City of Miami Beach
Last Completed Item Reviews Across All Submittals

Permit Type: Building - Commercial **Work Class:** Alteration (w/o Phased) **Application Date:** 05/22/2020 **Status:** Approved
Address: 235 WASHINGTON AVE **Permit:** BC2013662

Re: Response to City Comments.

Sobe Hostel
235 Washington Ave.
Miami Beach, Florida

PROPOSED RCP LEVEL 1 & 2

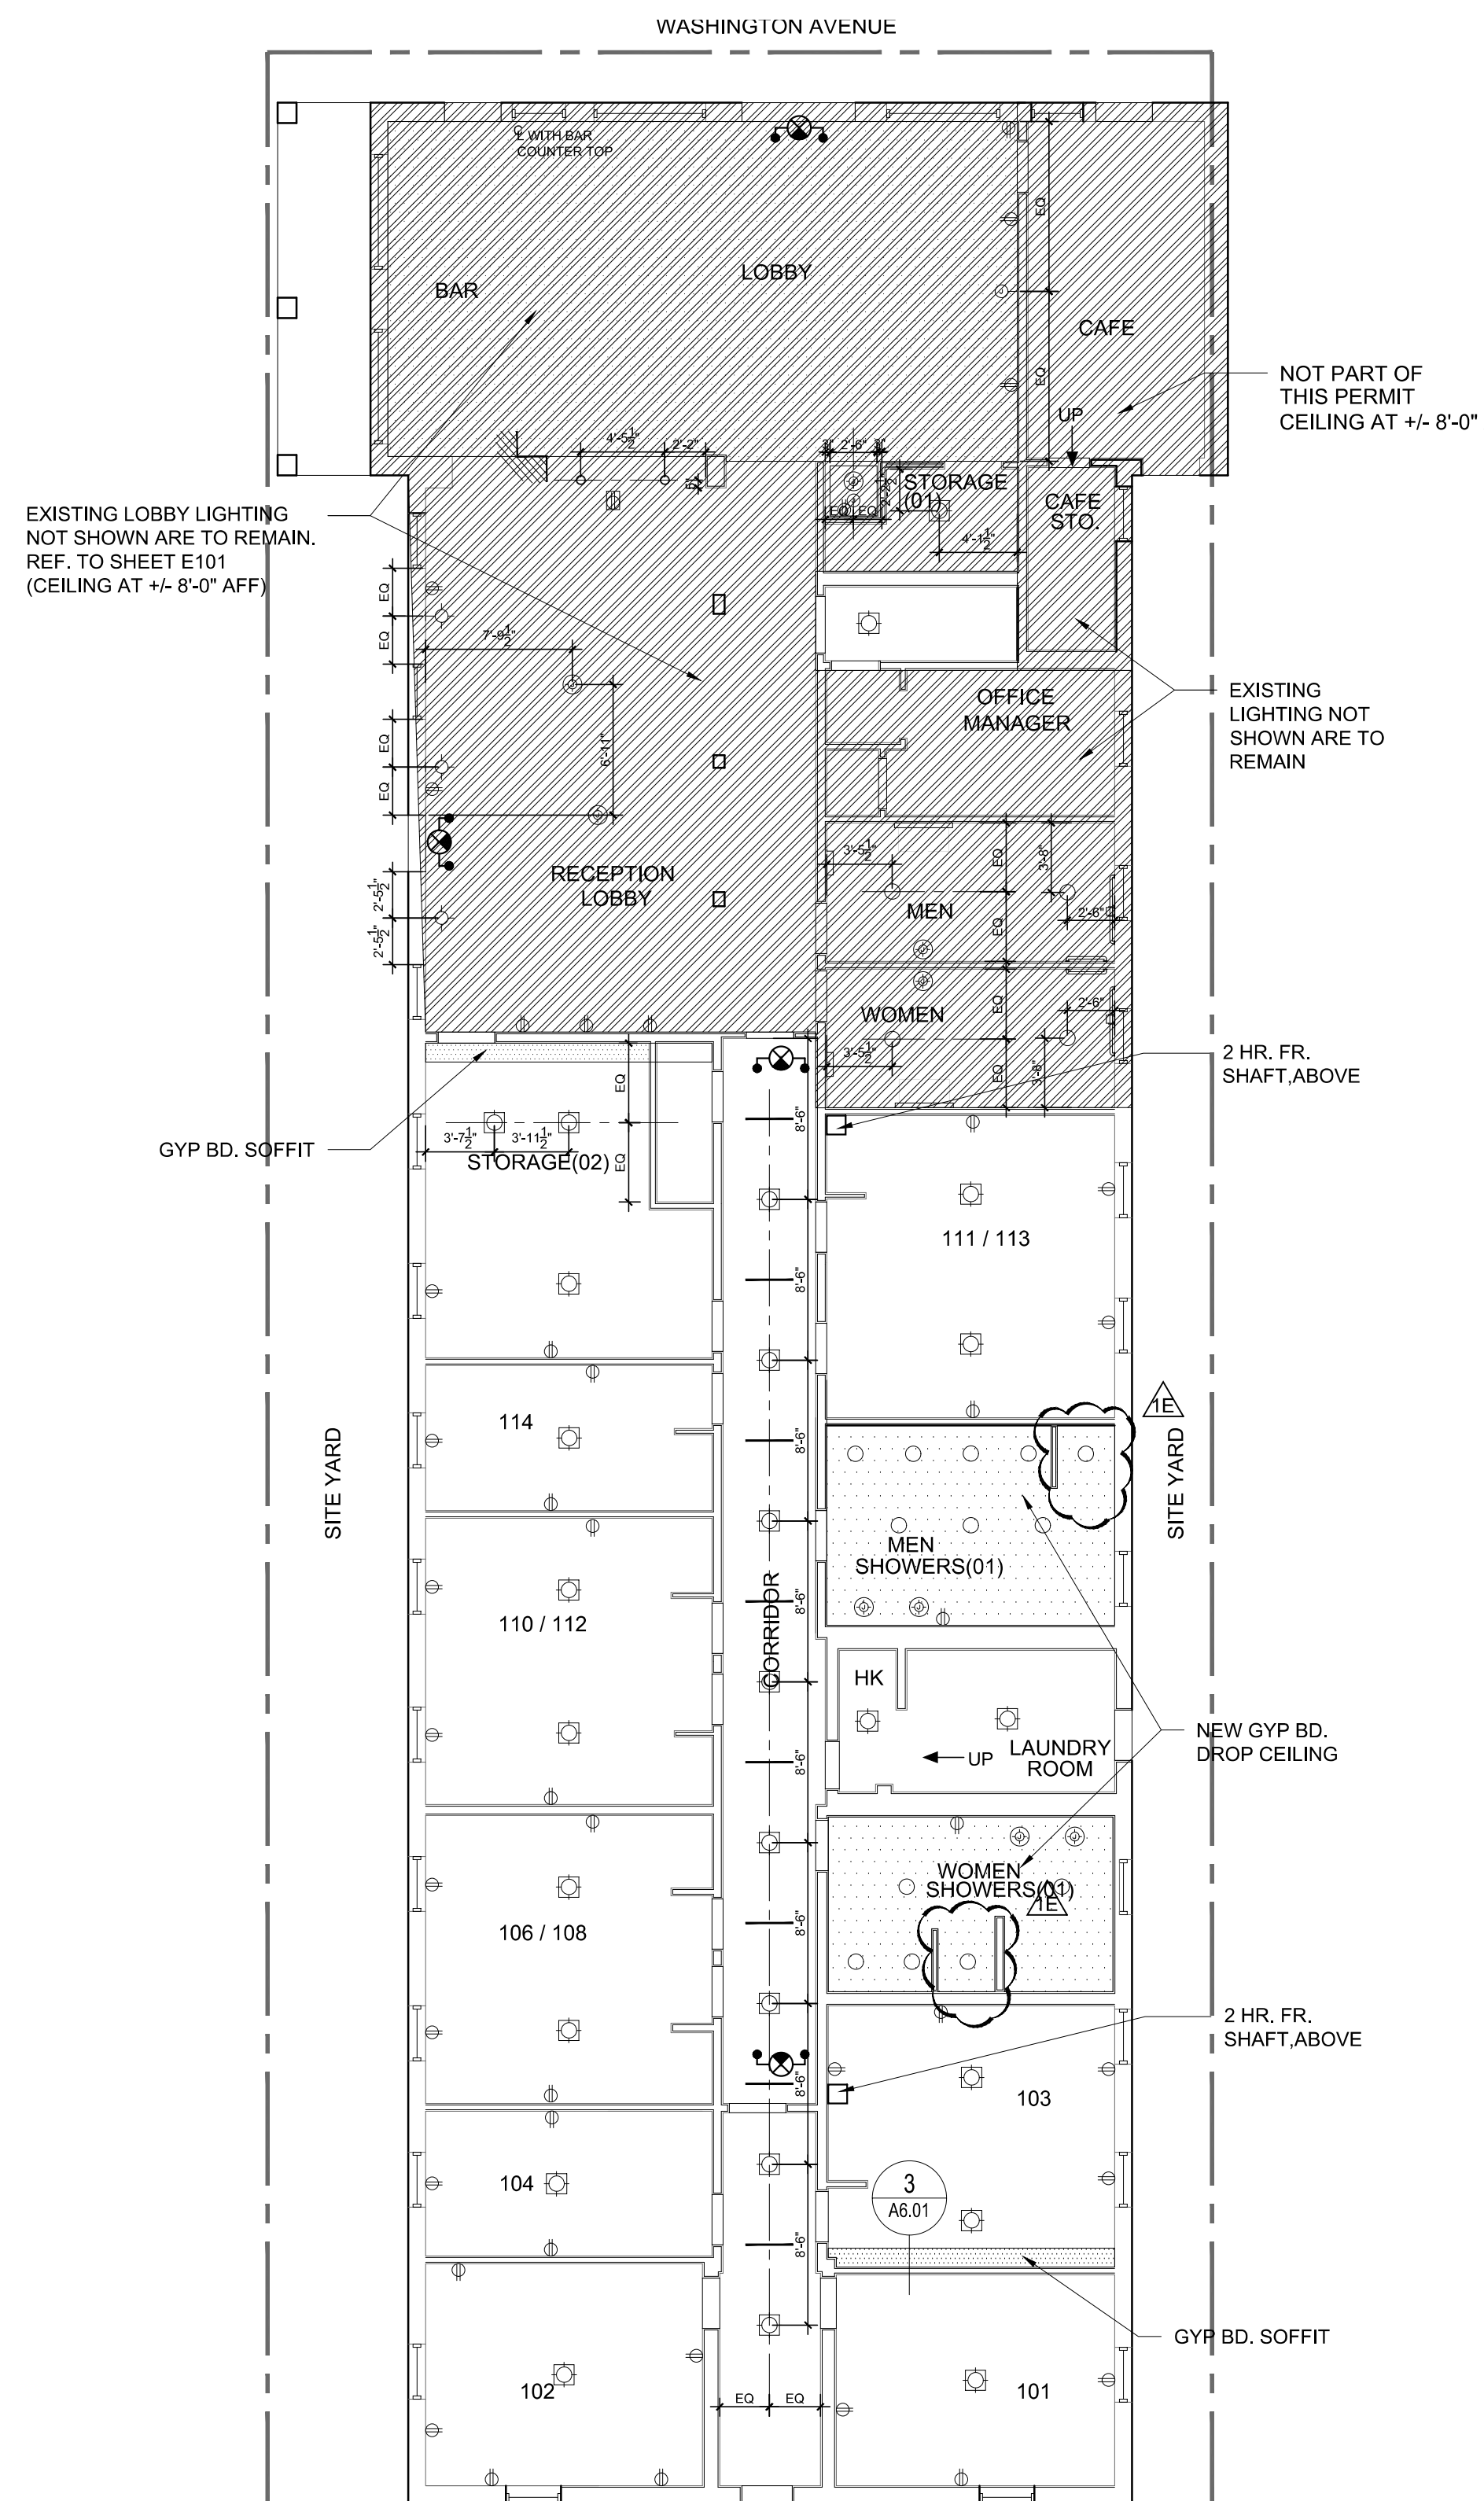
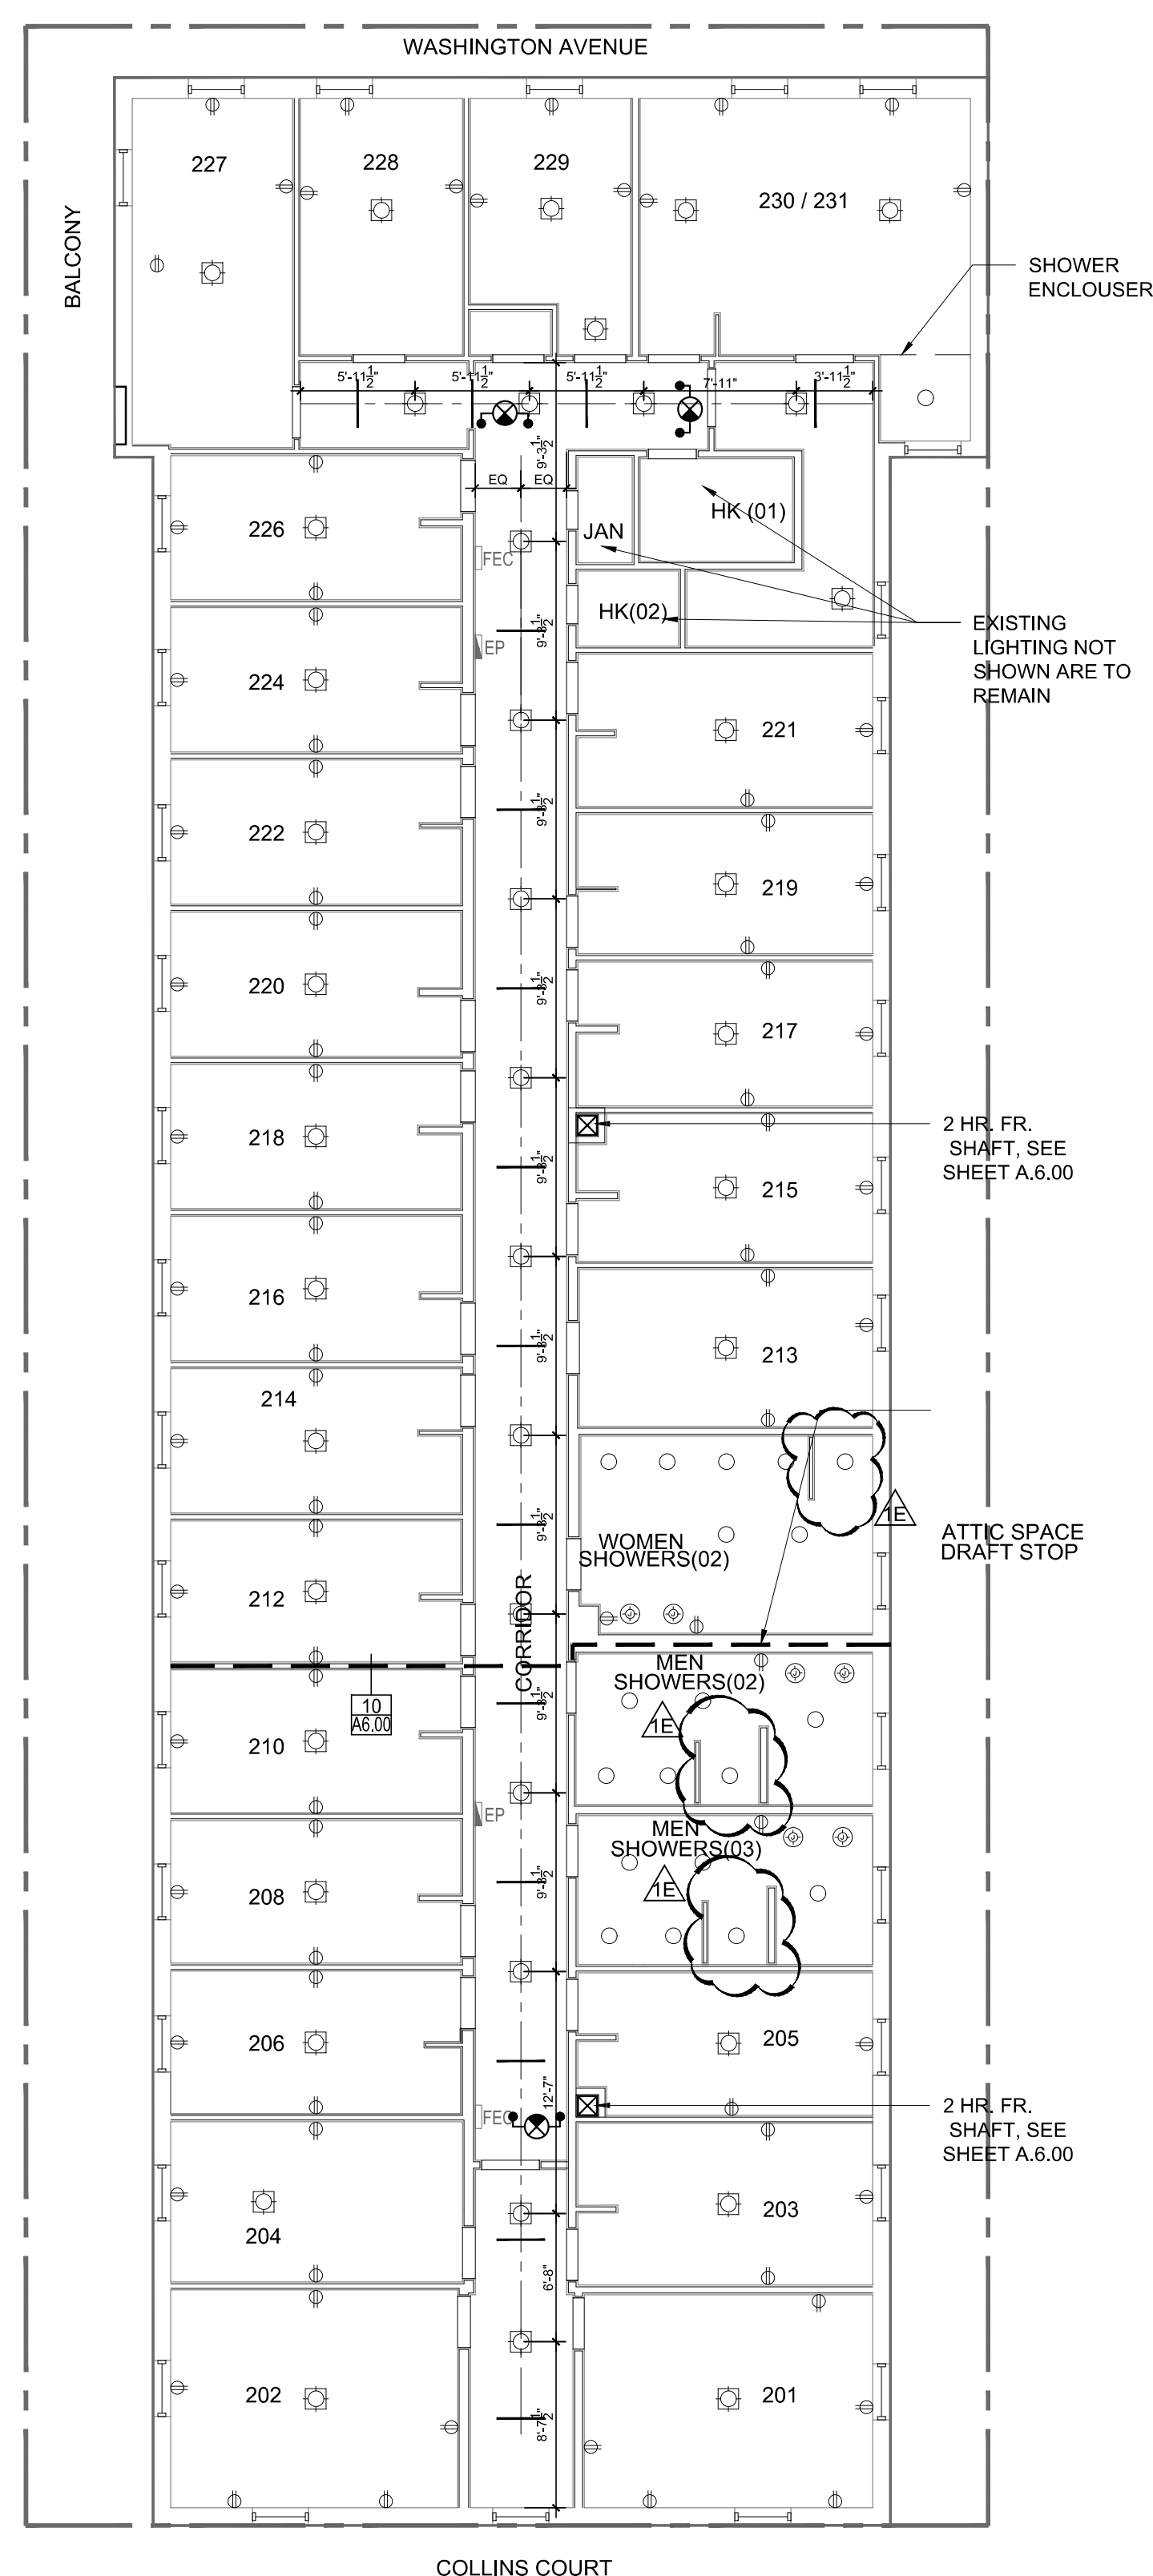
1. Provide ceiling height throughout (including hatched area) to verify compliance with the ffpc 6th ed 7.1.5 headroom

KKAID Response: Refer to ceiling legend for existing and proposed ceiling heights, clouded as #1A. Cross hatched area ceilings are existing to remain at height as shown
